MEMO LETTER

TO: City of Hobart Board of Public Works
FROM: Andrea Langille
CC: Brandon Towle, Jake Dammarell
DATE: January 23, 2019
JOB NO.: 4950
SUBJECT: 61st Avenue and Wisconsin Street Roundabout

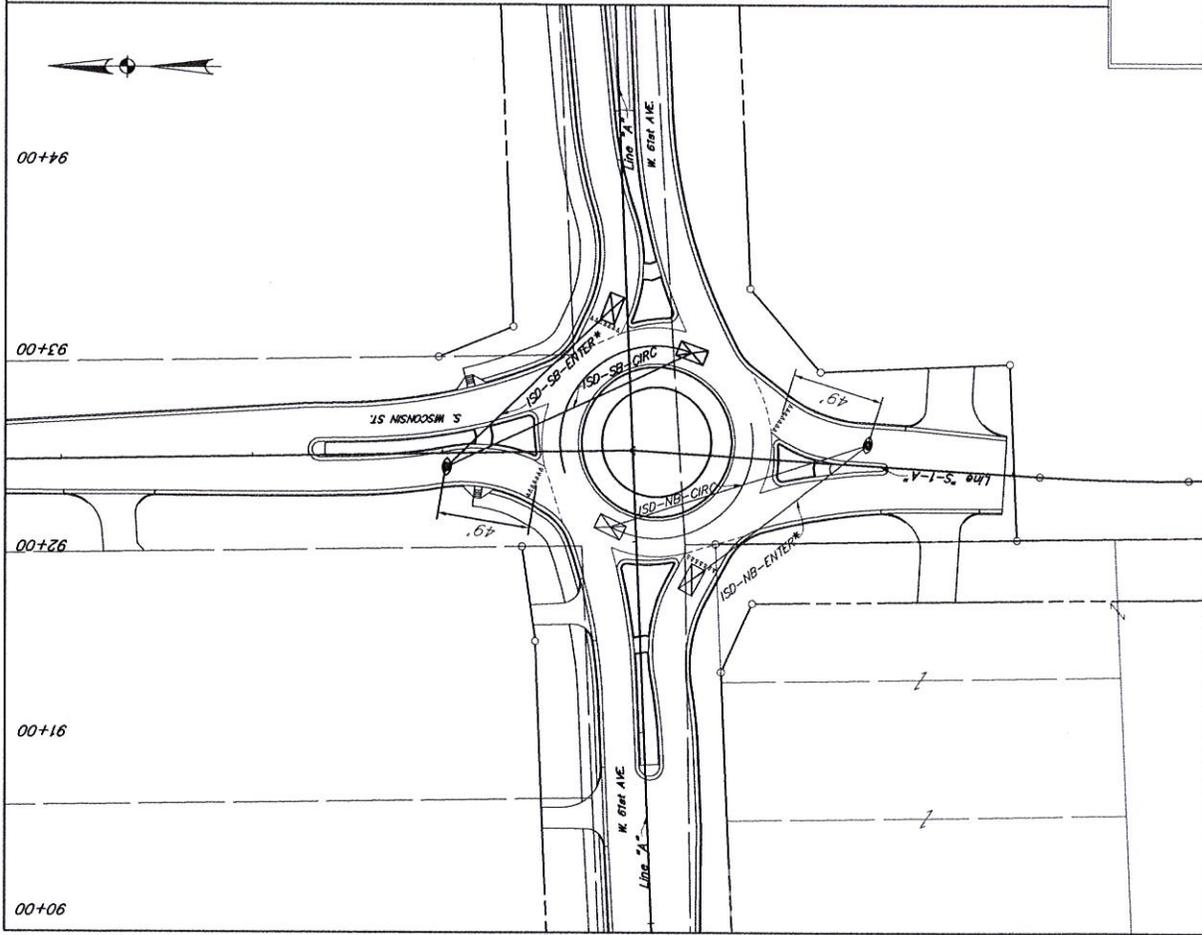
It has been brought to our attention that a letter of concern about the roundabout at 61st Avenue and Wisconsin Street has been submitted to the Board of Public Works for consideration. The concern is related to the tall masonry wall in the center of the roundabout and its impact on sight distance. The letter noted that the masonry wall obstructs the view of oncoming vehicles and requests the removal of a portion of the wall.

We have reviewed the design and sight distance calculations for the roundabout and have confirmed that the sight-distance requirements needed to safely maneuver the roundabout have been provided. As you approach a roundabout you should be reducing your speed, looking to the left and yielding to the oncoming traffic from the left. See attached sight distance check. The wall at the center of the roundabout does not impact this sight distance. There is not a need to see through the wall to be able to see oncoming traffic from the left. The wall would however need to be removed to see traffic from opposite direction, which is not recommended.

Upon review of the design, sight distance and recommendations from FHWA and INDOT, we would not recommend removal of portions of the wall in order to provide visibility to oncoming traffic from the opposite direction. Required sight distance is not impacted by the wall.

Design Speed - Based on Fastest Path Calc.
 Eye Location - 48' from Field
 Circulatory Stream - 115'
 Object Height - 3.5'
 *NB Entering Stream - 240'
 *SB Entering Stream - 270'
 Circulatory Stream (All Legs) - 115'
 *City Manual ISD Method From M007
 Design Manual Ch. 51-12.08(9)
